Village of Oxford Planning Commission Agenda Tuesday, October 06, 2020 7:00 P.M. – Teleconference ONLY

Re: Village Ridge – Village of Oxford, Oakland County, Michigan

Response to Review Letter

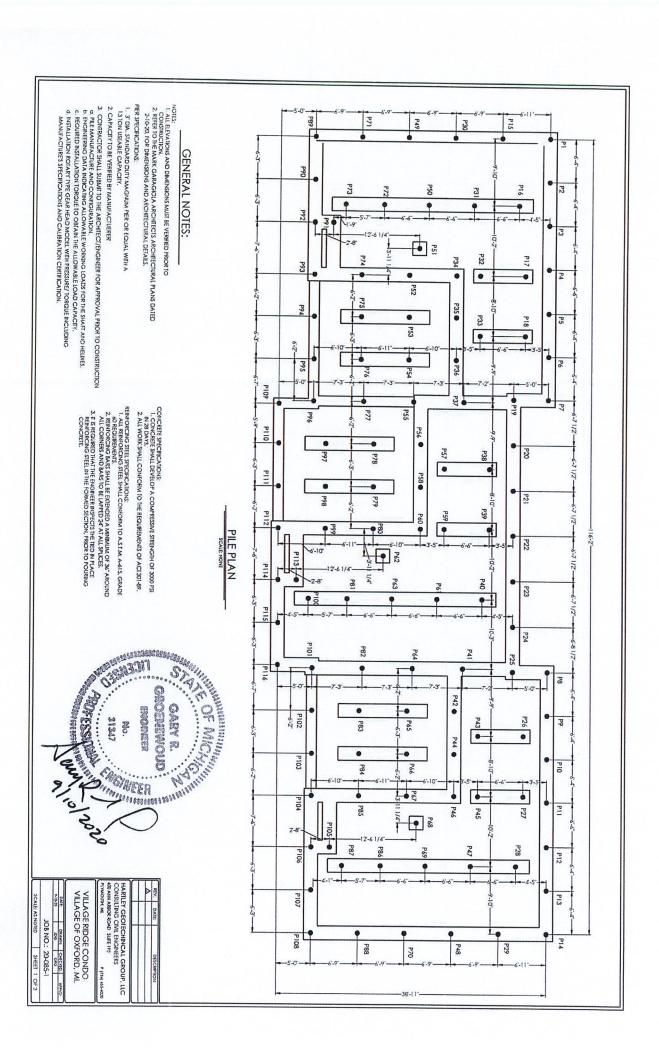
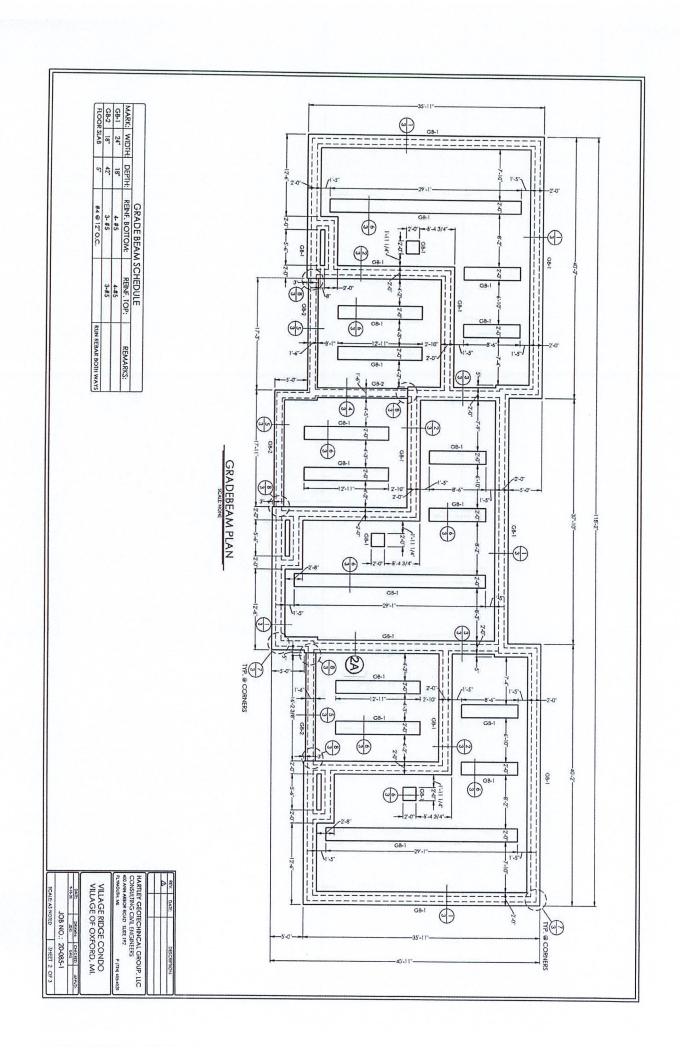
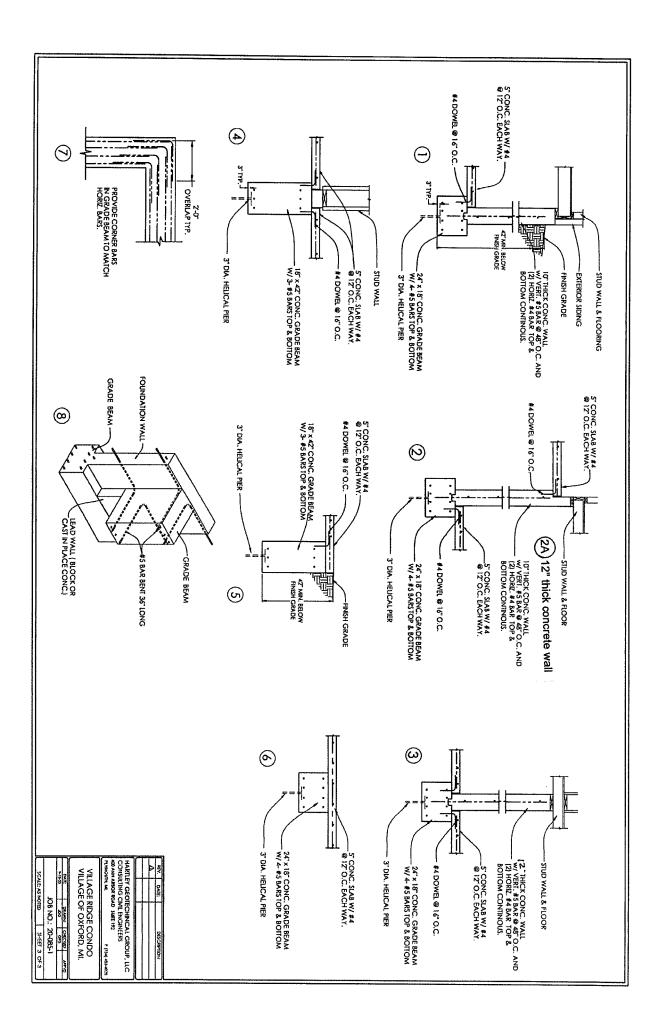
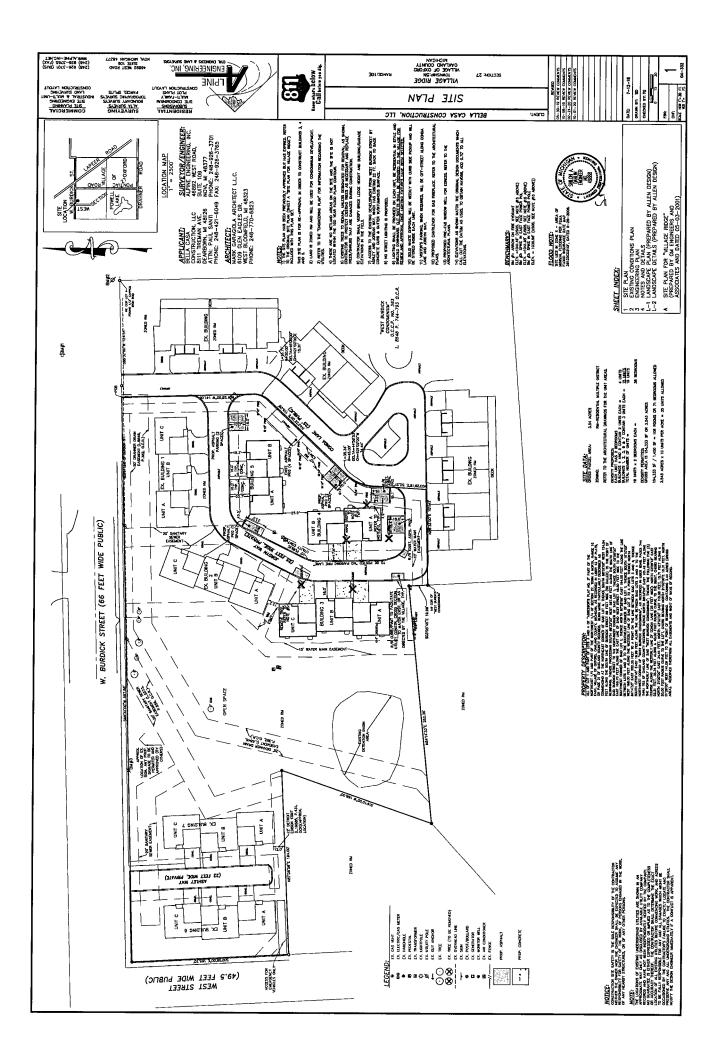
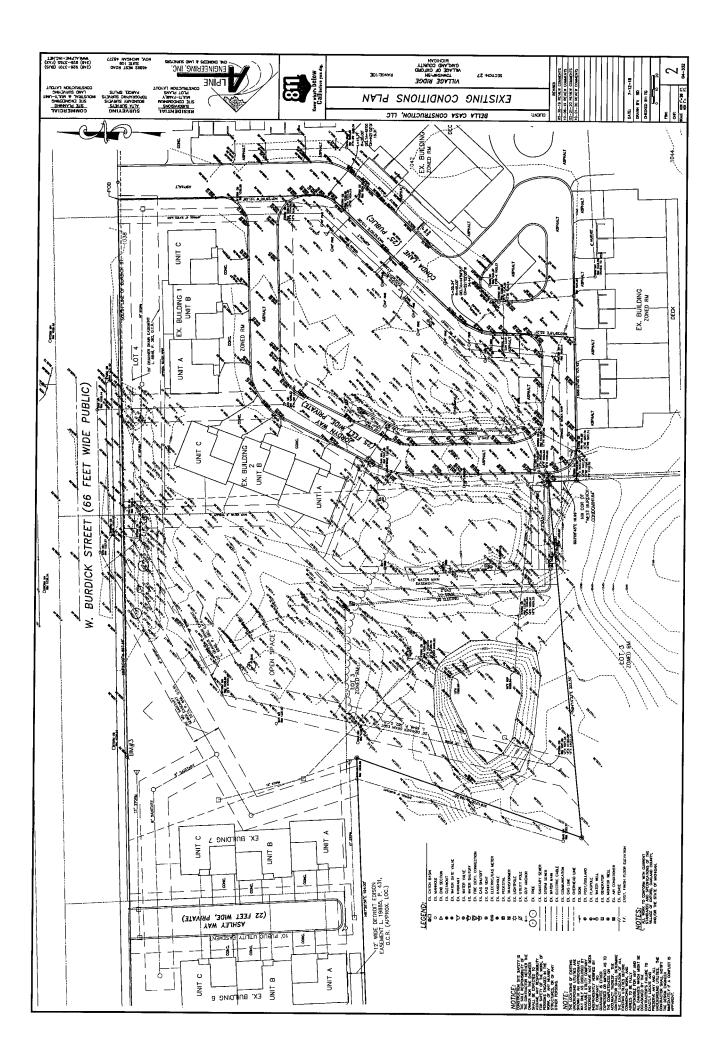
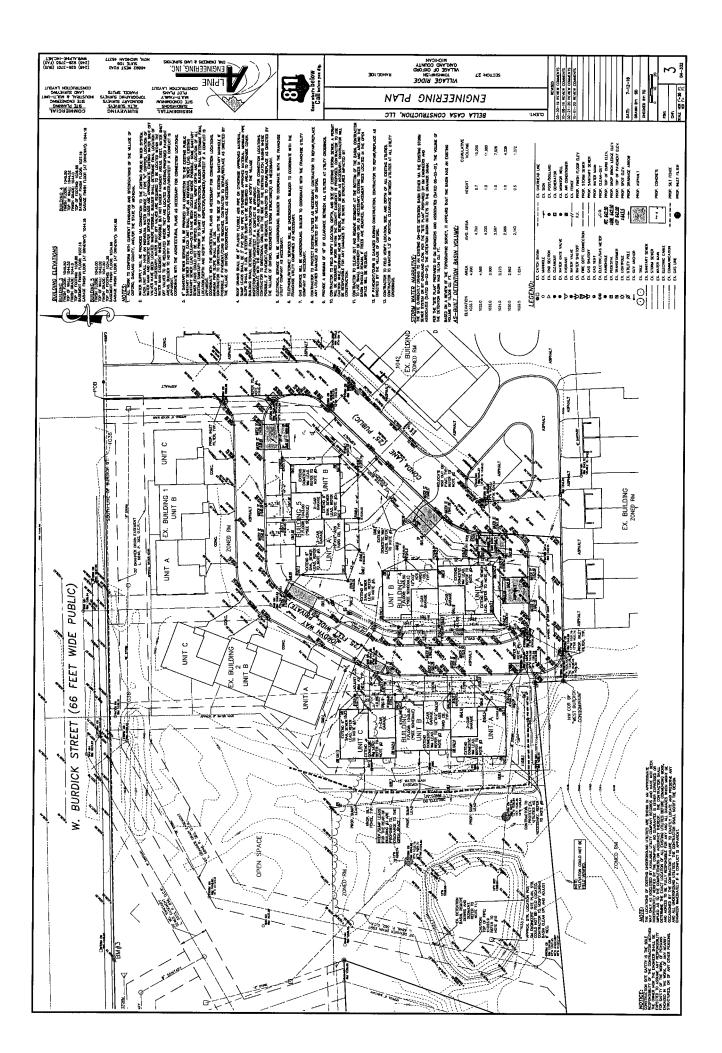
1. Comment: On-site Bituminous Pavement Cross Section --- The detail refers to 6" compacted MDOT 21AA aggregate or 8" compacted MDOT 22A aggregate. MDOT 22A aggregate is not an acceptable substitution for 21AA aggregate. This comment has been addressed; however, we offer the following comment for the applicant's consideration: The applicant could consider modifying the proposed pavement section to be 2 inches of asphalt base to provide a more stable base section when placing the top 1.5 inches. Additionally, the applicant might consider a different asphalt mix. The designated 1100 mix is a coarse mix, perhaps MDOT 13A would work better and is commonly used on residential streets.

- 2. **Comment:** Notes 2 and 3 refer to "the City" and should be revised to refer to "the Village". This comment has not been addressed on the Engineering Plan sheet 3.
 - Response: "The City" references have been revised to reference "the Village". Refer to the "Engineering Plan".
- 3. **Comment:** Our June 28, 2019 review letter asked a question about an easement for the existing sanitary sewer system, which according to the general notes it is a public sewer. This comment has not been addressed on the engineering plans or Exhibit B documents.

Response: The pavement cross section has been revised. Refer to the "Notes and Details" sheet.

Response: The sanitary sewer easement has been added. Refer to the Civil Site Plan set and the "Survey Plan" of the Exhibit Bs.

Title: Landscape Plan

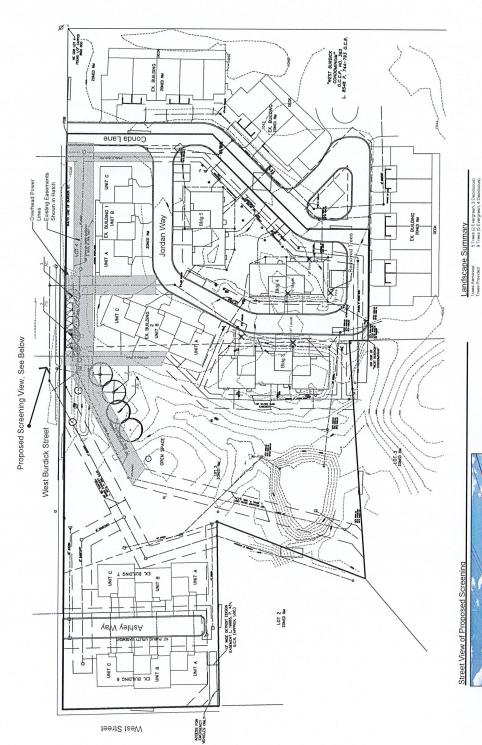
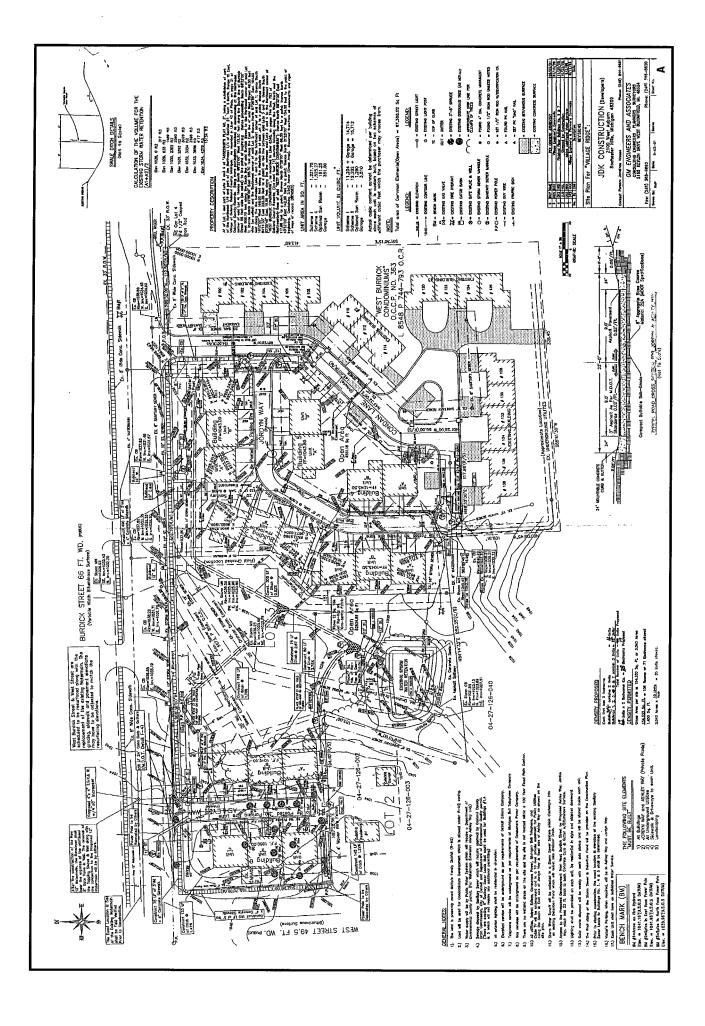
- **Response**: The boundary line has been shifted to match the survey drawing prepared by Kennedy Surveying Inc and dated November 20, 2015.
- 2. **Comment:** The Planning Commission should determine if the proposed landscaping meets the intent of the ordinance standards in their opinion based on the scale of the construction before granting final site plan approval.

- **Response:** Per the request of the Planning Commission, a street view elevation has been prepared by the Landscape Architect. Refer to the Landscape Plan.

EXHIBIT "B" TO THE SIXTH AMENDMENT TO THE MASTER DEED OAKLAND COUNTY CONDOMINIUM SUBDIVISION PLAN NO. 1167

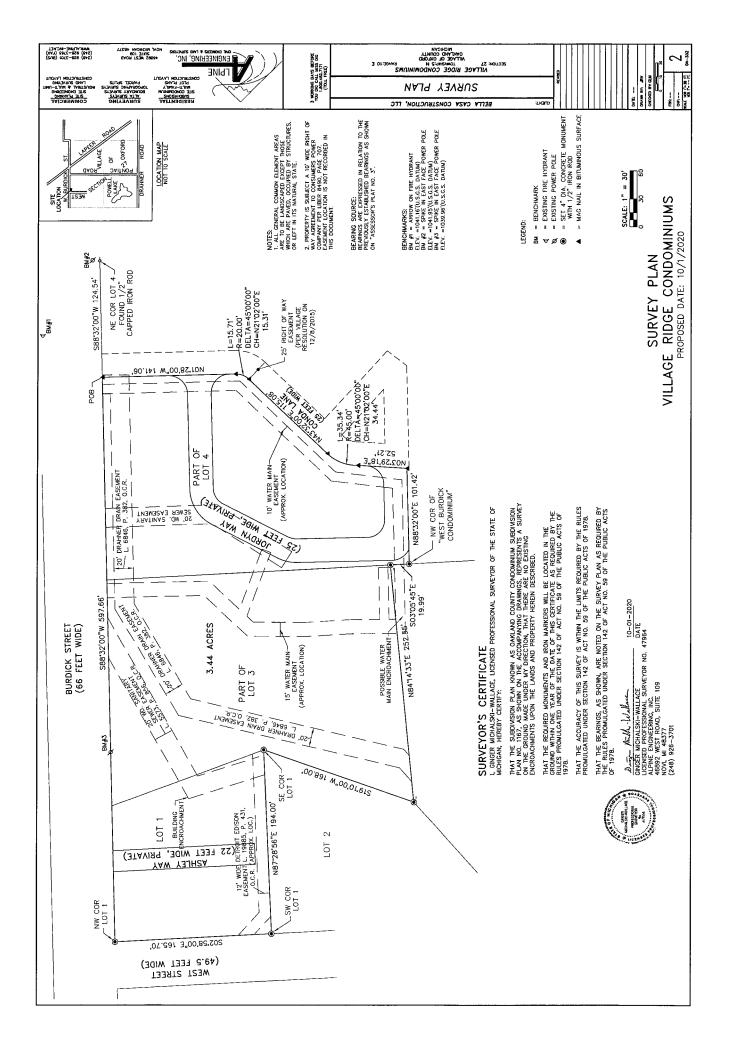
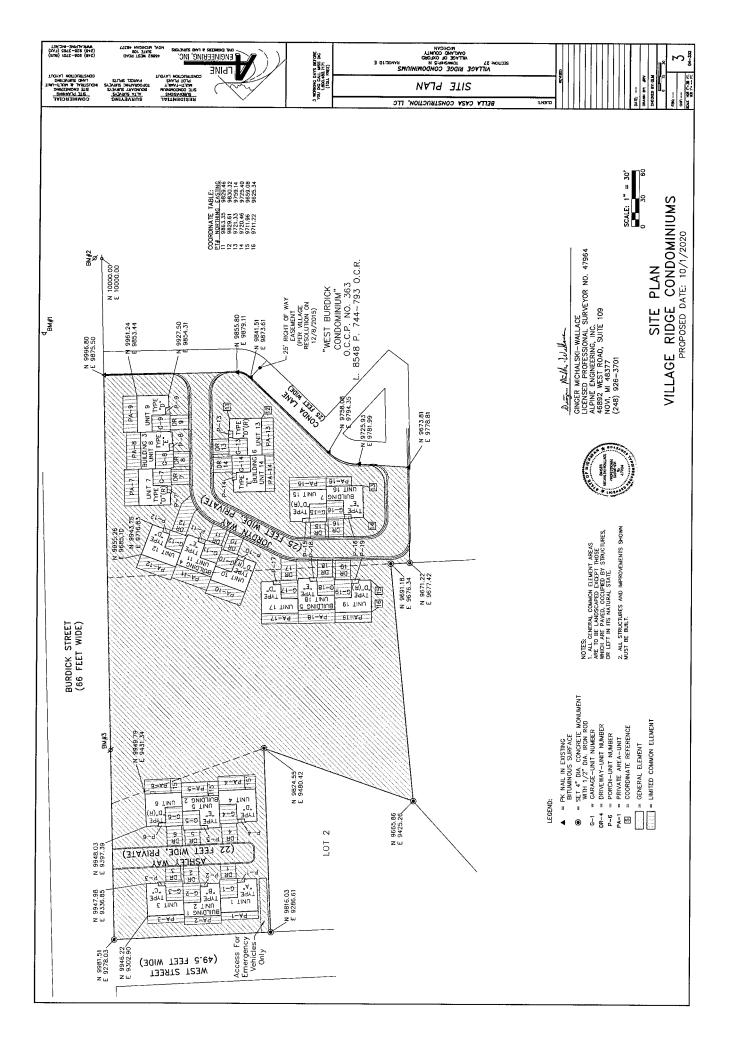
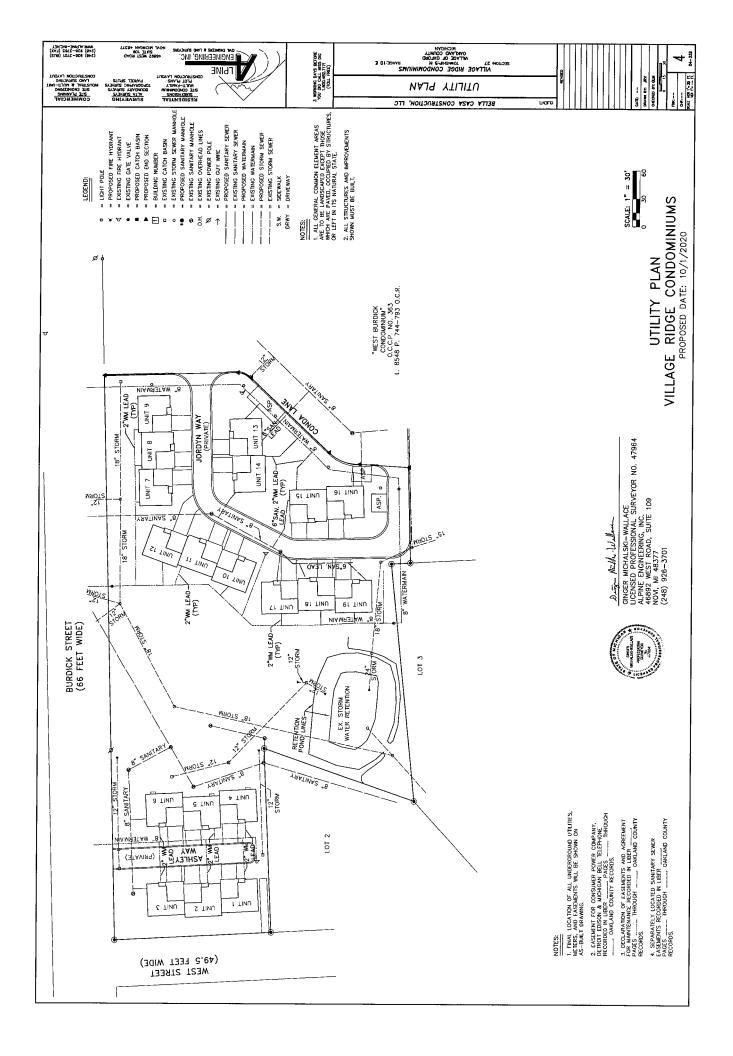
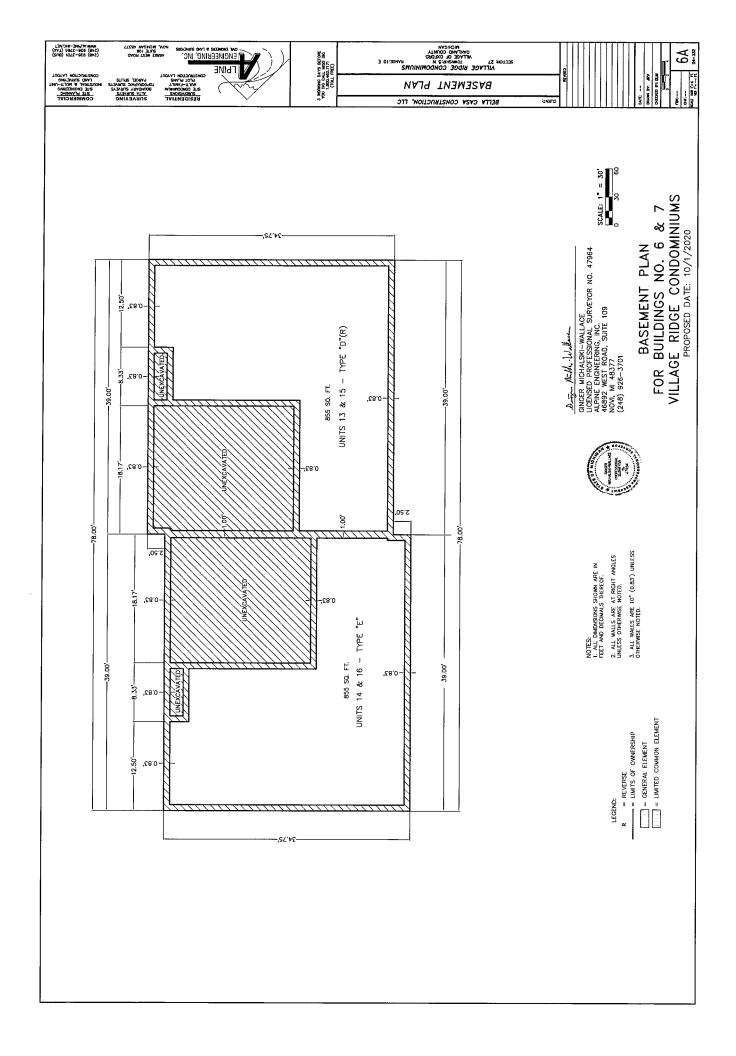
- 1. **Comment:** The applicant must shift the condominium boundary line west to remove Conda Lane from Village Ridge's general element area. This is a minor revision and Planning Commission approval of the final site plan should be contingent upon a recording of a revised Exhibit B.
